NRC RAIs Regarding GGNS PRNM System LAR

Entergy Operations, Inc.
GE Hitachi Nuclear Energy

May 25, 2010

PRNM System Overview (cont'd)

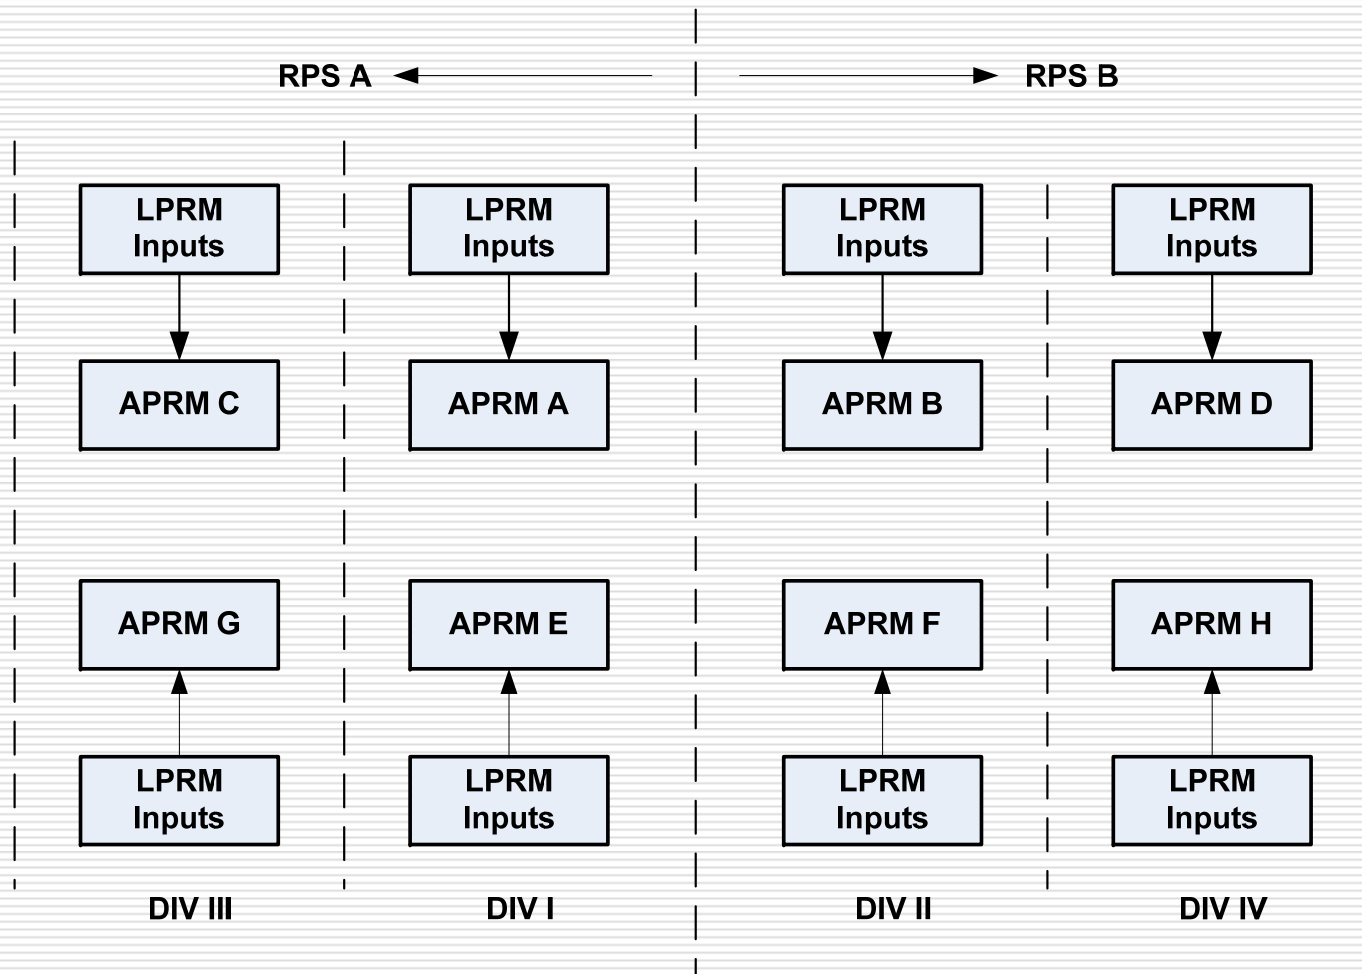
- Supports plant operation at higher power levels

- Supports a different core stability solution needed for extended power uprate conditions
 - Changing from Option E-I-A to Option III
